Permit Type	Permit Number	Opened Date
Building/Residential/Alteration/SFD	B25000648	02/19/2025
Description of Work		
SFD/ FIRST FLOOR ALTERATIONS TO CREATE BEDROOM, BATH AND CLOSET IN EXISTING SUNROOM

PROJECT:
BEDROOM RELOCATION

From: Oswald Jr, Woodin
Sent: Tuesday, March 4, 2025 7:54 AM
To: Sycamoredb - new
Subject: RE: B25000648_12816 Amberwoods Way_Floor Plan Questions

BASEMENT AS BUILT
N.T.S.

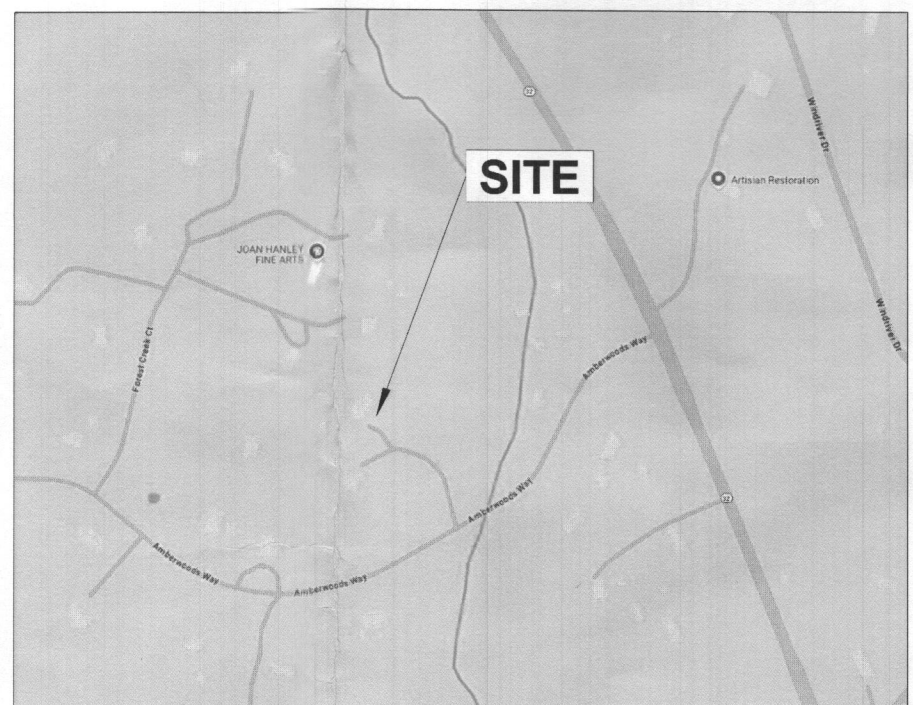
No bathroom & no rough in per email dated 2.27.25

1. Is there a full bathroom or a full bathroom rough-in in the basement?
2. Does the office on the 2nd floor have widows?

No bathroom in the basement and no rough in. The sewer exits mid wall of the basement.
No ejector pit.

2ND LEVEL AS BUILT
N.T.S.

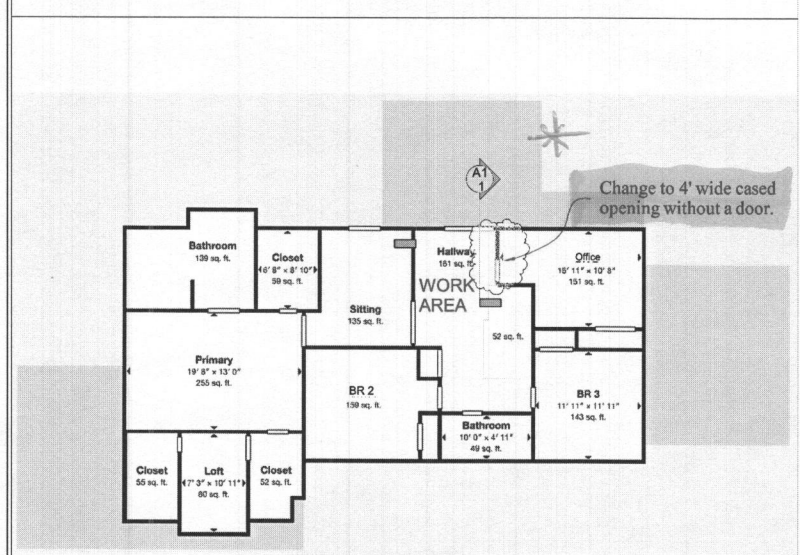
Change to 4' wide cased opening without a door.

I should have been more specific about the floor plan. Would you add a note to the floor plan next to the work area to indicate “change to a 4 foot wide cased opening without a door”. I saw the letter, but we need to see the note on the floor plan so it’s clear.

The entire opening into the room must be 4 foot wide cased opening without a door and labeled as such. Why are you proposing to open just the upper half? I understand the one room with the railing in the way, but what about the other room with the picture frames on the wall? Couldn't that be opened from top of door frame to the floor?

Thanks for the quick reply. The room labeled "office" on the 2nd floor meets the definition of a bedroom under local code (please see attached). With that said, the floor plan shows 4 bedrooms on the 2nd floor. You are proposing an additional bedroom on the 1st floor. According to the septic record, the septic system was sized for 4 bedrooms (see attached). The 1250 gallon tank is only adequate for 4 bedrooms. There appears to be enough linear feet of trench to accommodate a 5th bedroom. At this point, the homeowners could choose to install a larger septic tank to accommodate a 5th bedroom or reduce the # of bedrooms on a revised floor plan by choosing one of the following.

1. Show a 4 foot wide cased opening without a door into one of bedrooms.
2. Show permanently built-in bookcases, a permanent desk or other permanent features around the perimeter of the room to basically prevent it from being used as a bedroom.
3. Show a half wall (4 foot max height) between the room and another room

Good morning. Thanks for the updated floor plan showing a 4 ft. wide cased opening w/o a door into one of the bedrooms on the 2nd floor. I've approved the building permit under the condition that this residence remains at 4 bedrooms under local code bedroom definition with the above-mentioned change.

After all that we are widening the door and patching in the floor. Revised plans uploaded.
